Troy Schools District

**RFP #2324-22
BP#3B Smith Middle School - ARCH & MEP & Civil -
Addendum #2
July 15th, 2024**

Troy Schools District – BP#3B Smith Middle School – ARCH & MEP & Civil – Addendum #2

Addendum #2 Bidder Clarifications

DRAWING NO.
M6.6

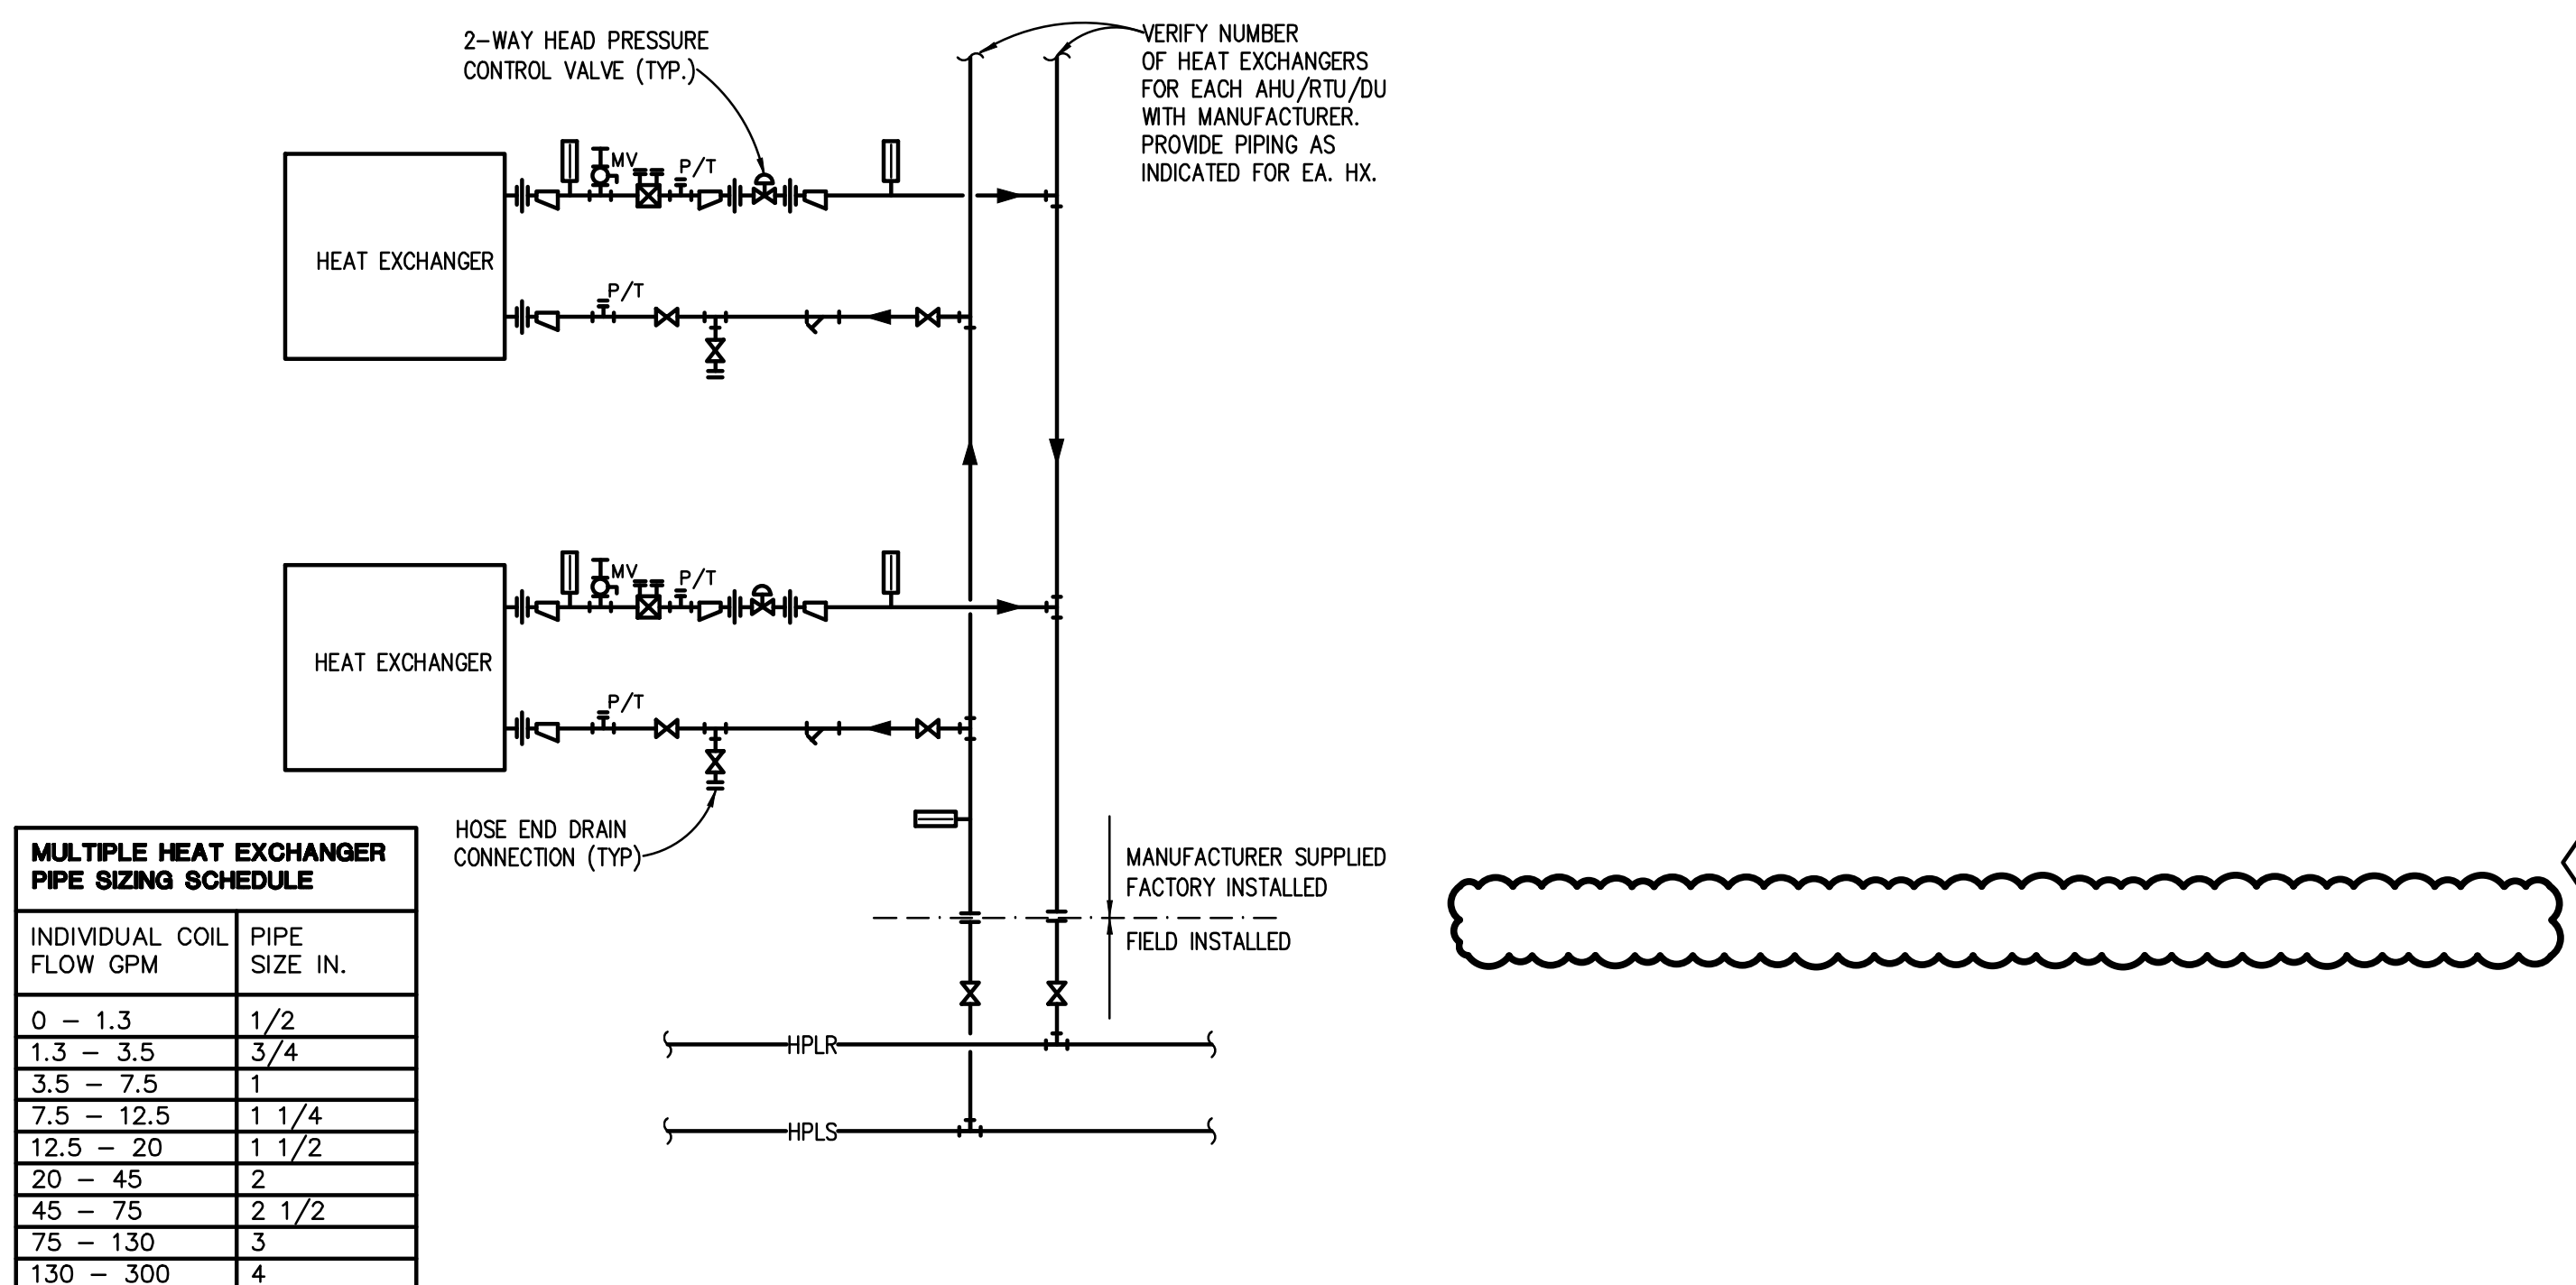
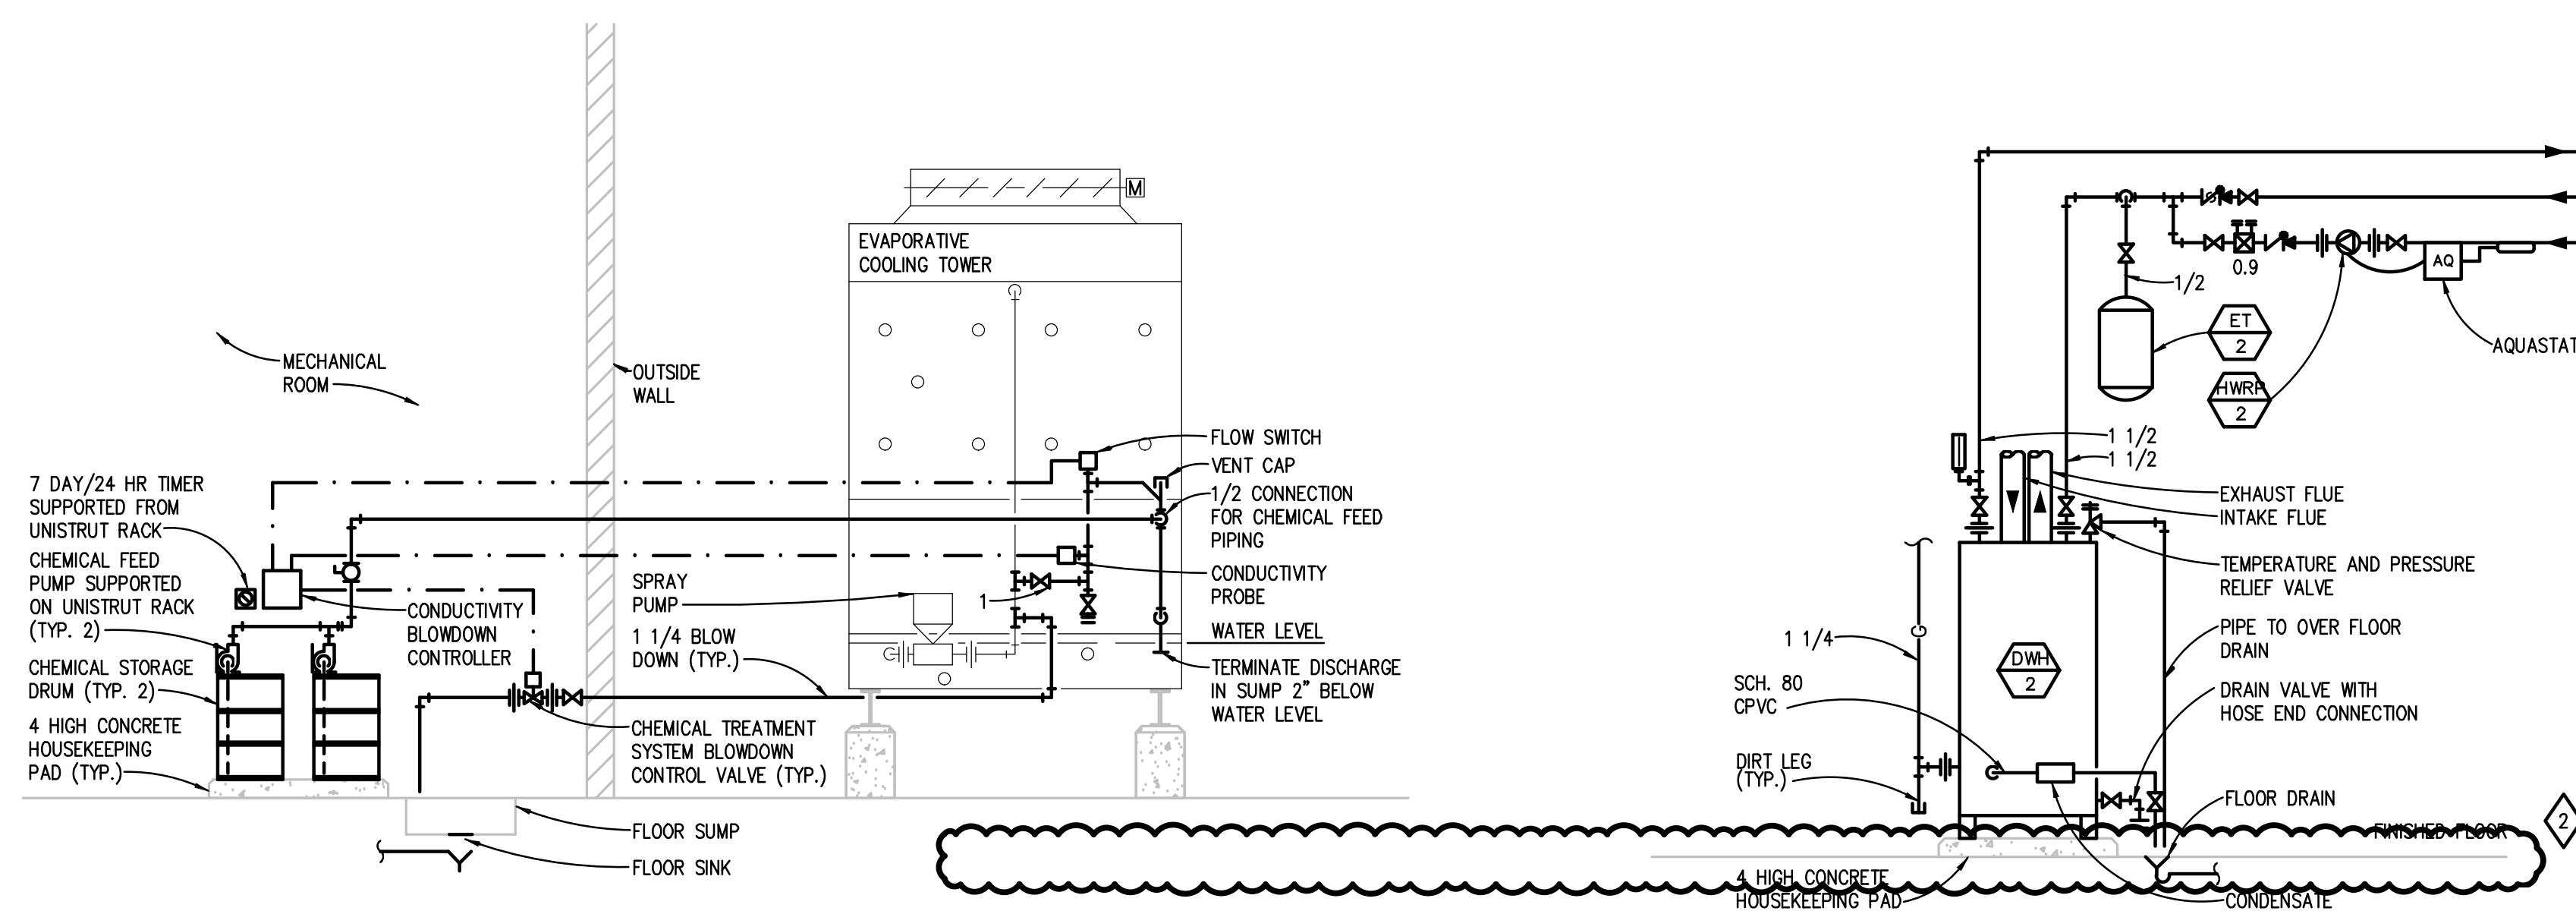
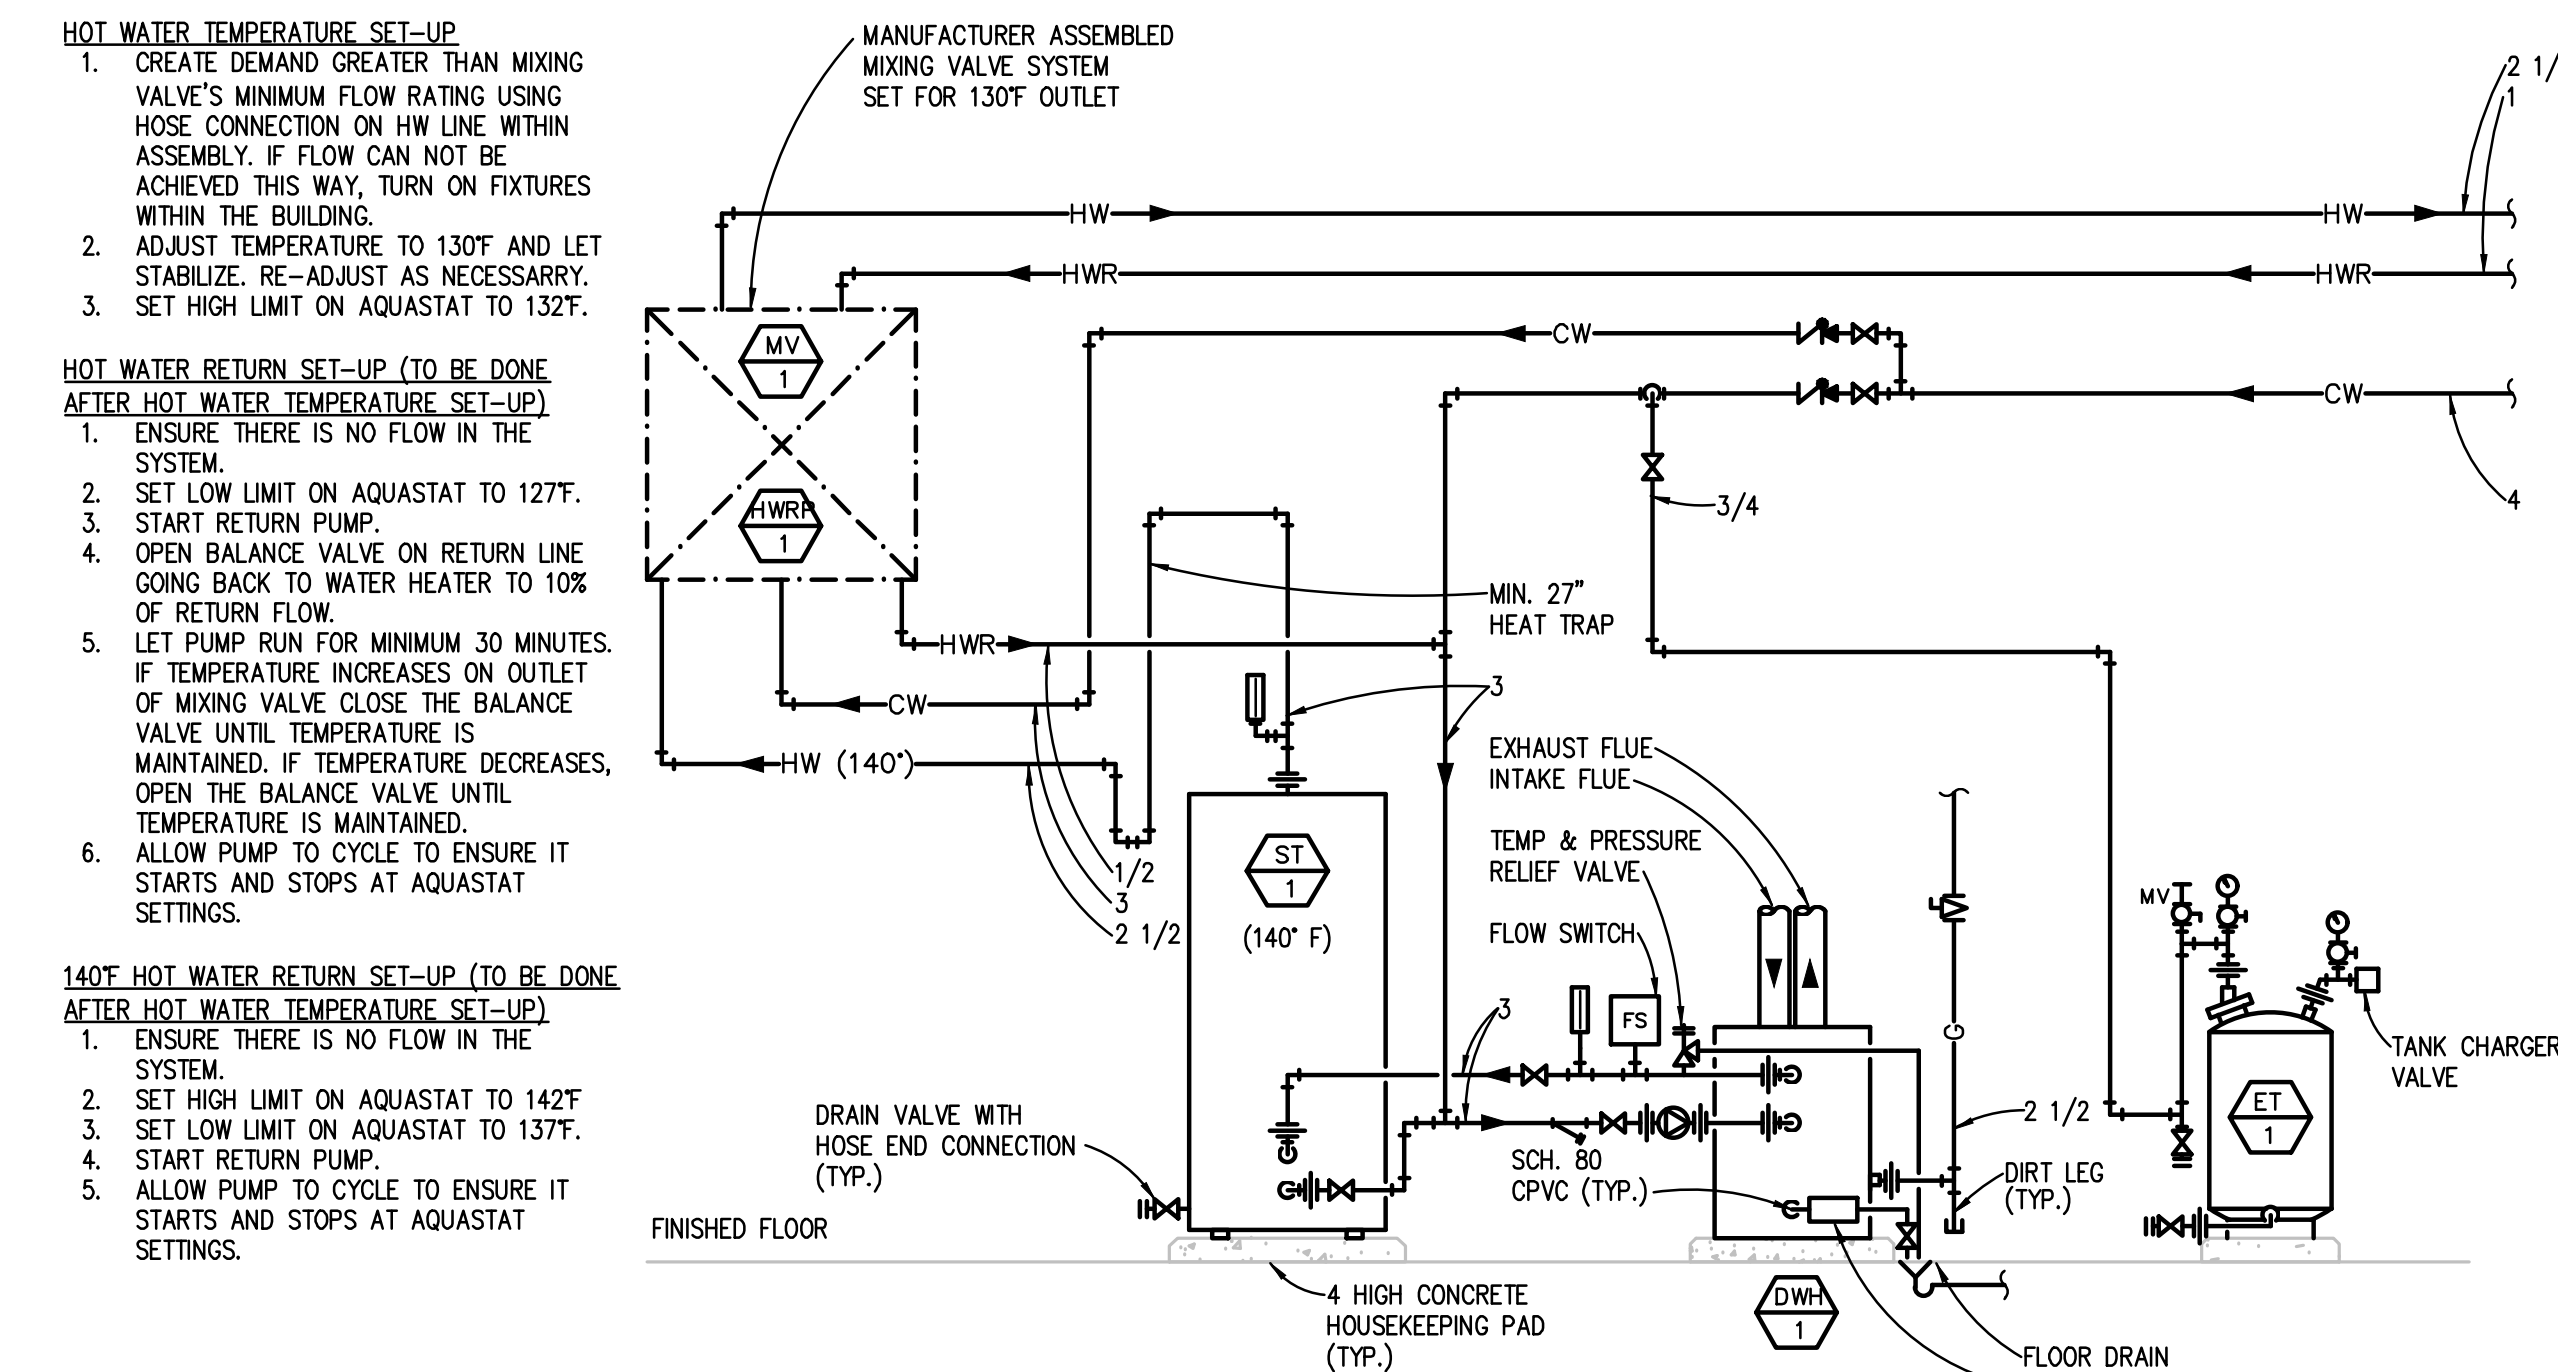
- A. Moved detail for printing clarification as indicated.
- MD-18 Refer to Drawing No. M6.6 (reissued):
- A. Revised details for printing clarification as indicated.
